# ADA TRANSITION PLAN (*DRAFT*)

## **RIGHT OF WAY AND FACILITIES**

Adams County

Rear Lobby

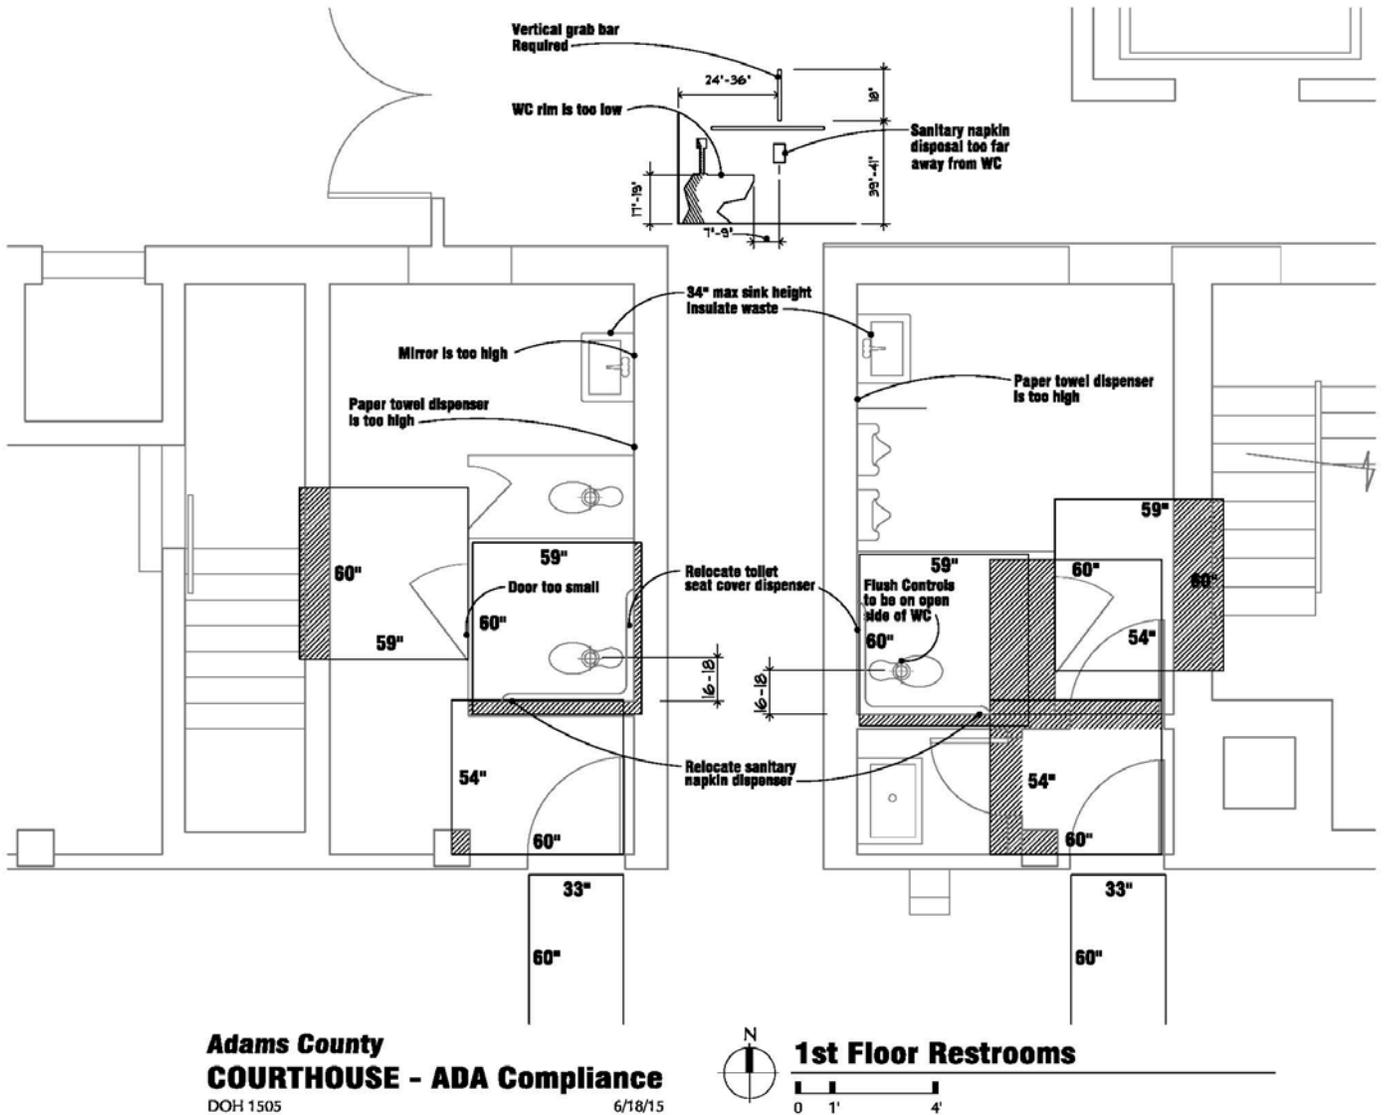
The rear entry is not a public entry, but the public has access to the restrooms at the rear lobby. There is adequate clearances in the space. An ADA Ramp has been installed. Since the ramp is not part of the public access, it was not evaluated.

**1st Floor Restrooms - Concept**

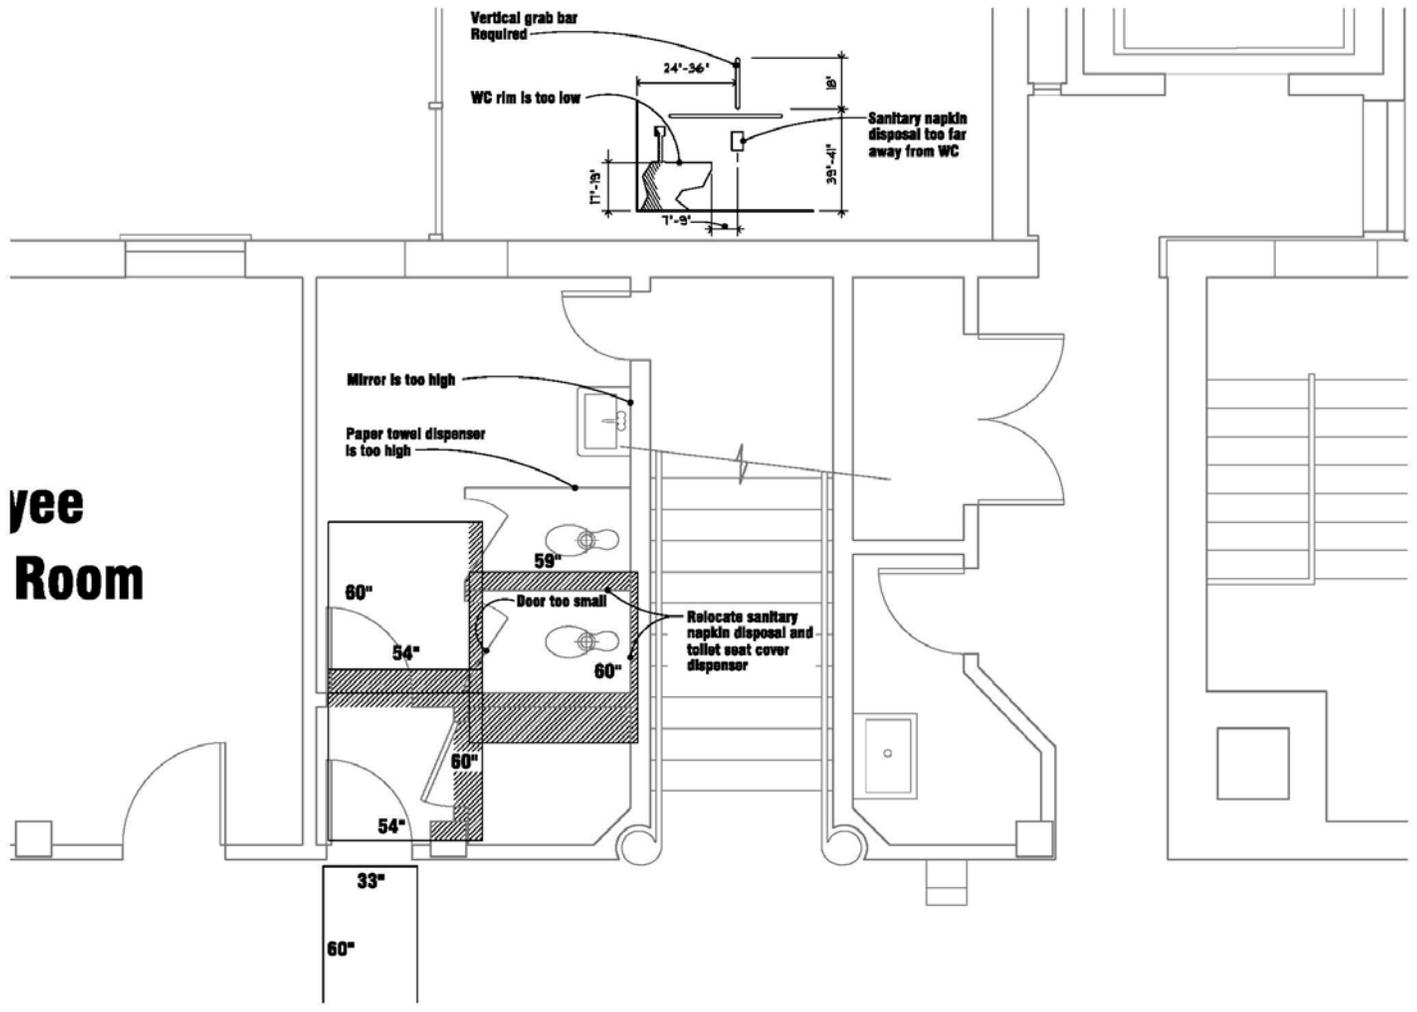
*Recommendation: Demo all specialty items, fixtures, compartments and walls within the room. Provide a wing wall or partition at the pull side of the wall to provide 54" clear from the column. Provide a new lavatory and counter adjacent to the new wing wall, with a standard toilet compartment to the north side of the lavatory. At the north end of the room locate the accessible toilet compartment with a door opening to the south. Reinstall all specialty items.*

*Recommendation: Demo all specialty items, fixtures, compartments and walls within the room. Remove the hall side door and wall to the extent possible. Provide a new lavatory and counter adjacent to the south side wall, with two urinals to the north side of the lavatory. At the north end of the room locate the accessible toilet compartment with a door opening to the south. Reinstall all specialty items.*

**2nd Floor Restrooms - Concept**

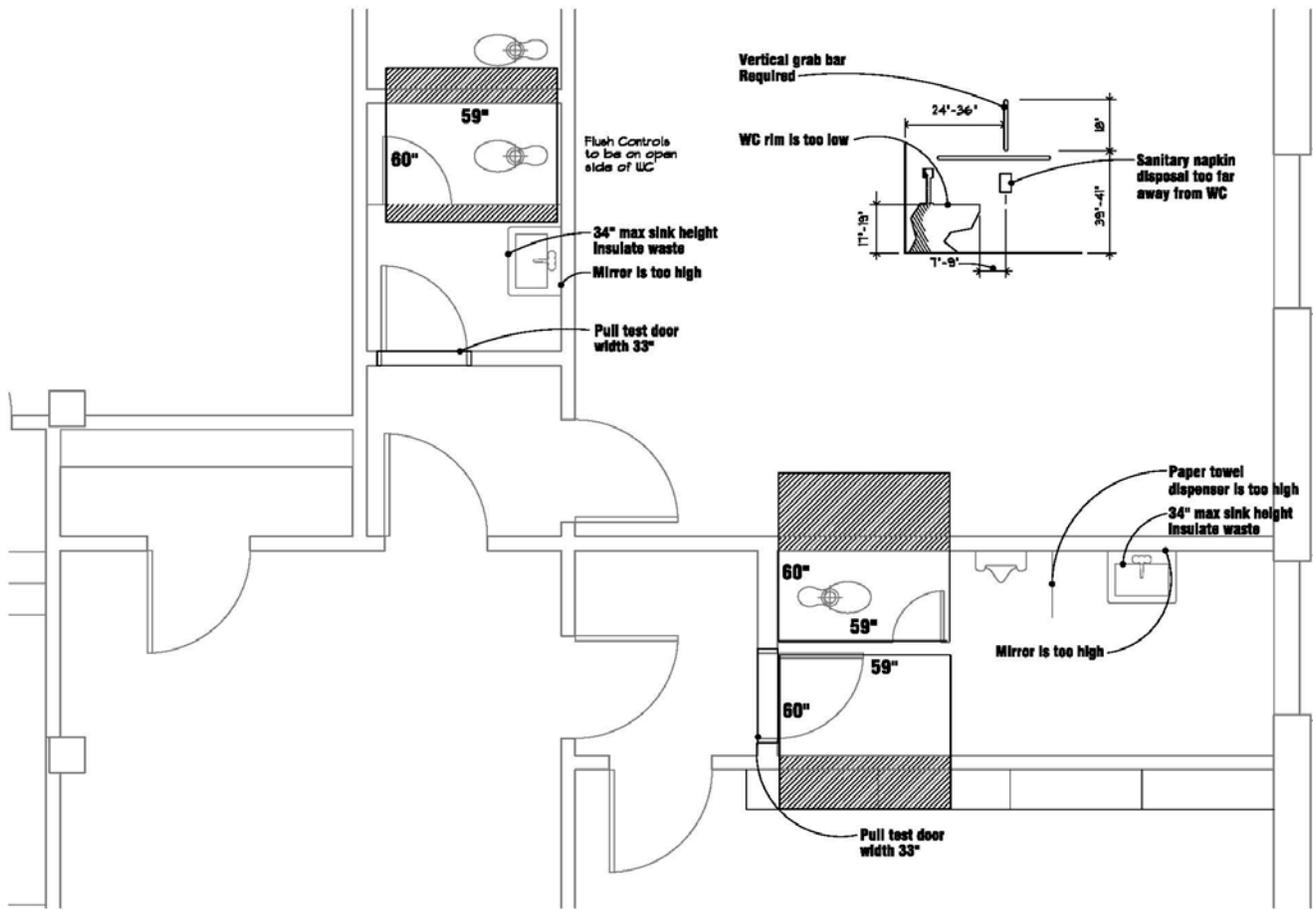
*Recommendation: Demo all specialty items, fixtures, compartments and walls within the room. Remove the hall side door and wall to the extent possible. Provide a new lavatory and counter adjacent to the south side wall, with one standard size toilet compartment to the north side of the lavatory. At the north end of the room locate the accessible toilet compartment with a door opening to the south. Locate the accessible water closet to the south side of the compartment to allow access to the door. Verify handrail length with door location to properly size the width of the toilet compartment. Reinstall all specialty items.*
